**BEFORE THE PUBLIC UTILITIES COMMISSION
OF THE STATE OF SOUTH DAKOTA**

**IN THE MATTER OF THE
APPLICATION BY DAKOTA RANGE
I, LLC AND DAKOTA RANGE II, LLC
FOR A PERMIT OF A WIND ENERGY
FACILITY IN GRANT COUNTY AND
CODINGTON COUNTY, SOUTH
DAKOTA, FOR THE DAKOTA RANGE
WIND PROJECT**

* **DAKOTA RANGE I, LLC AND DAKOTA
RANGE II, LLC RESPONSES TO
STAFF'S FIRST SET OF DATA
REQUESTS TO APPLICANT**

EL18-003
*
*
*
*
*
*
*

Figure 12
 Land Use and Project Layout
 Dakota Range
 Wind Energy Facility
 SDPUC Application

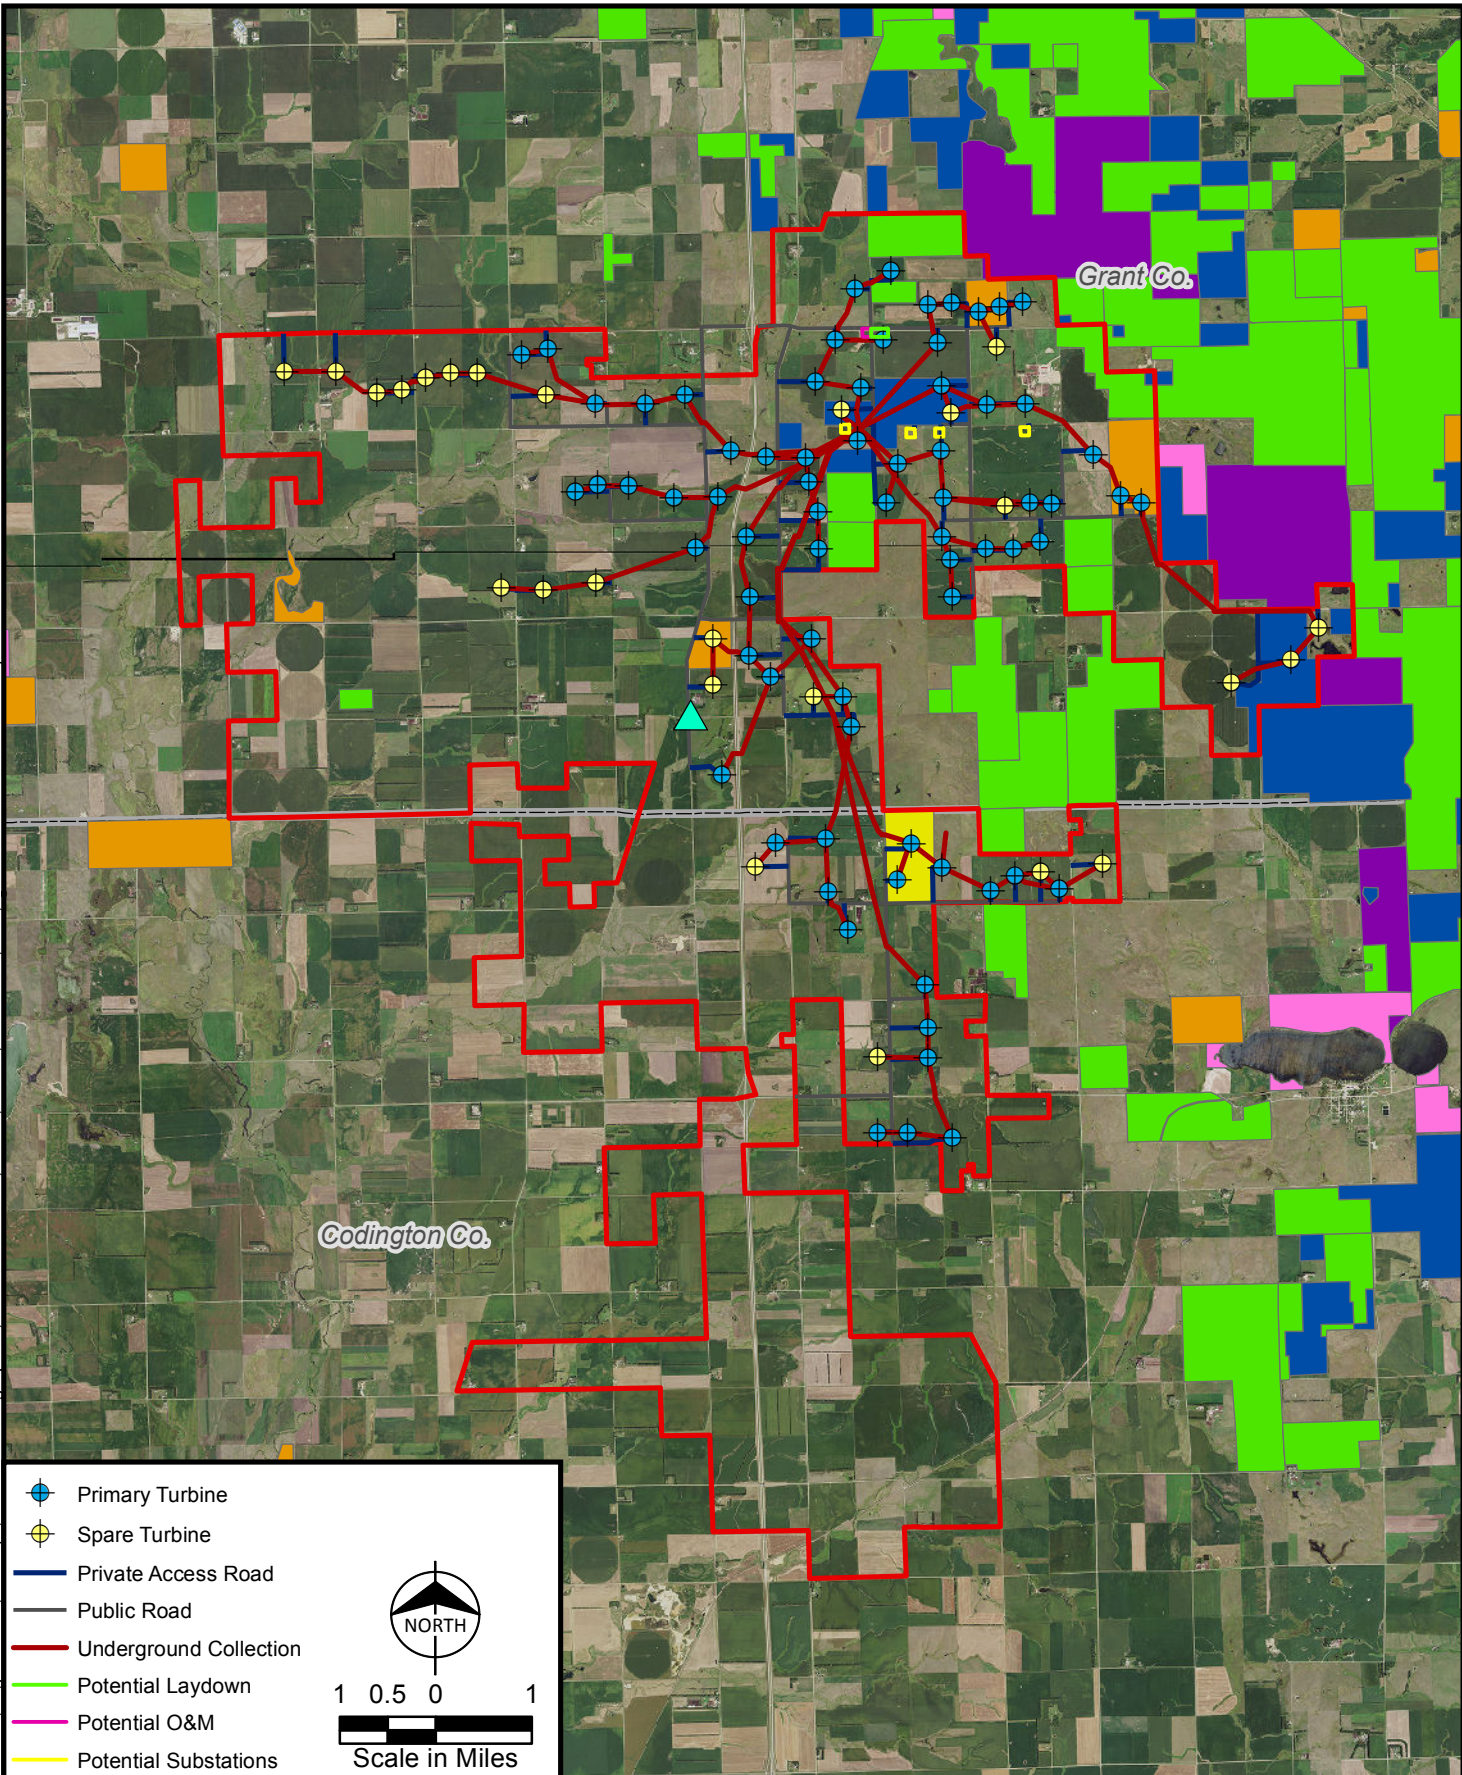
- 2-3) Referring to section 9.0, it is identified that “Figure 12 shows the locations of cemeteries, places of historical significance, and other community facilities (i.e. schools, religious facilities) within or near the project area.” Please identify how these locations are displayed on Figure 12.

- 2-4) Please provide Figures 12 and 13 with the proposed turbine layout included.

Jennifer Bell: One church and an associated cemetery are located within the Project Area. This church and associated cemetery is displayed on Figure 12 as a “Public, commercial, and institutional use” indicated by a purple hexagon. Note that the church and cemetery is the easternmost purple hexagon shown on Figure 12. The church and associated cemetery is also displayed on Figure 13 as a “Church and Cemetery” indicated by a turquoise triangle.

Buildable Within 500ft From Turbine

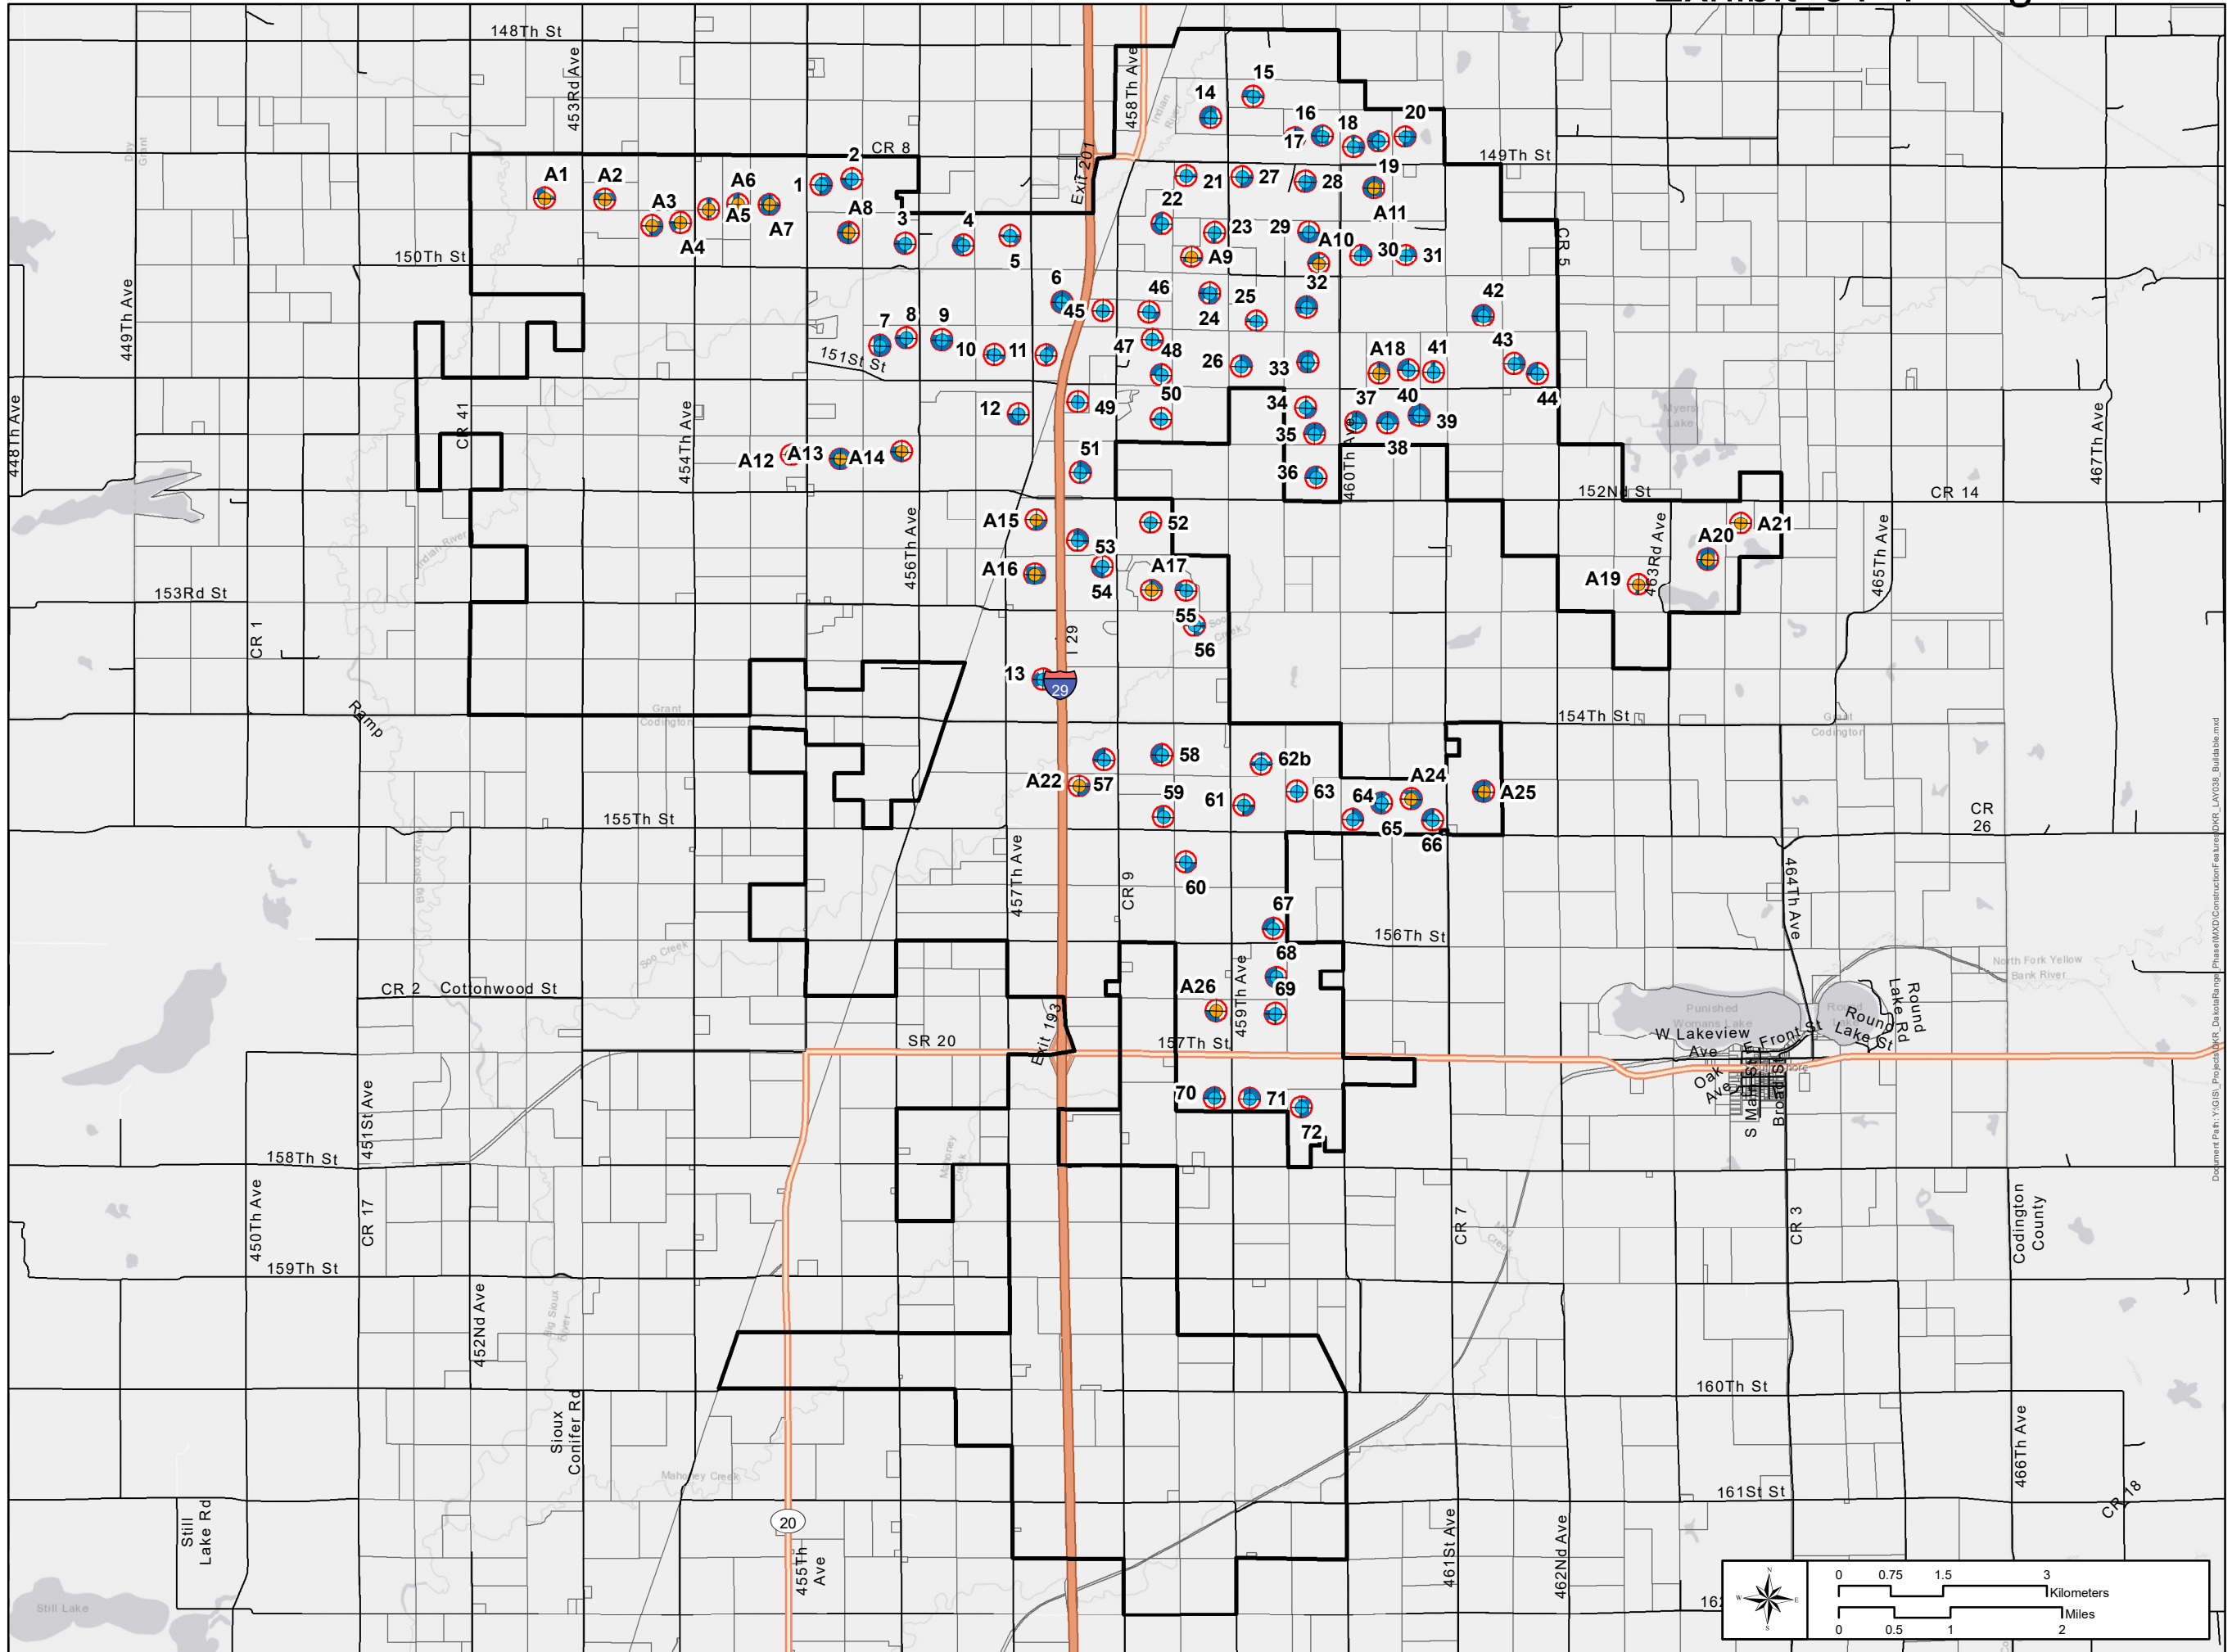
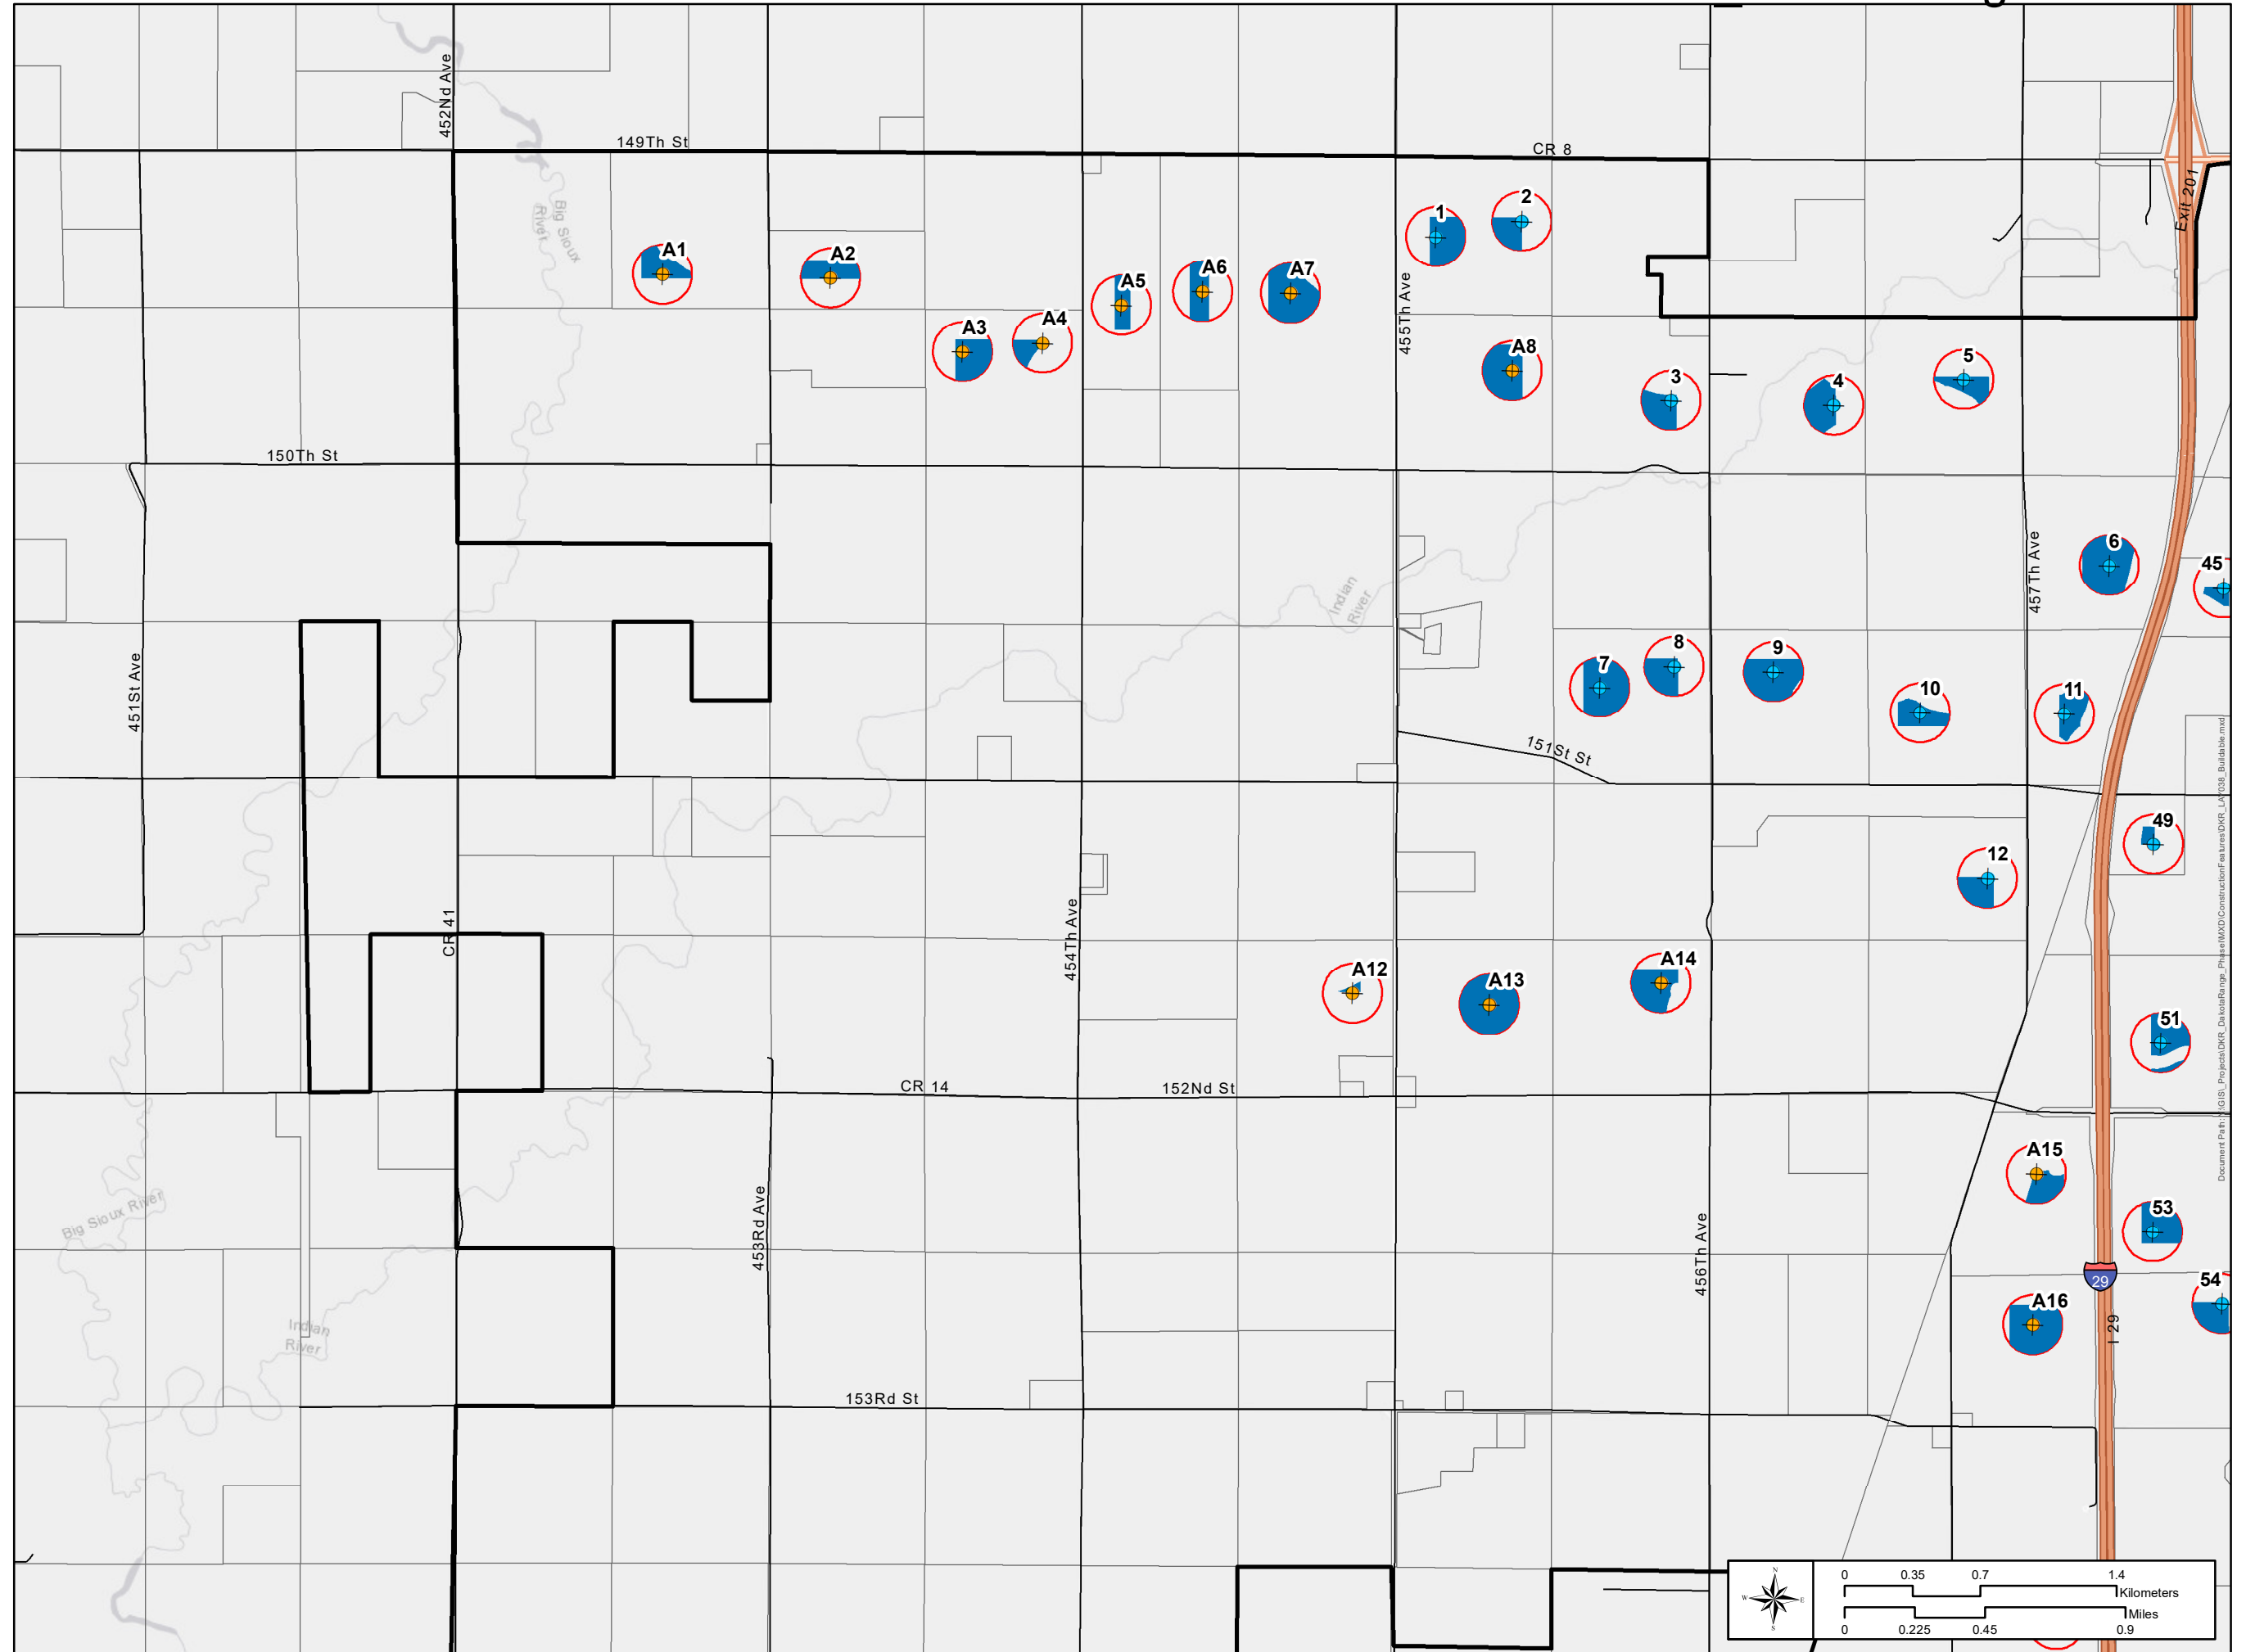
- 7-3) Please refer to the Constraints Map depicted on Figure 5:**

Brenna Gunderson: Turbines 16, 18, 19, and 20 are shown in a non-Buildable Area as a result of an error in creating Figure 5 in which an outdated version of the Buildable Area was inadvertently used.

- c) **Please resubmit Figure 5 to also show the turbine flexibility requested, and submit Figure 5 with more detail (ie – broken out into 4 or 6 sub-regions of the project).**

Brenna Gunderson: See the attached revised Figure 5 maps.
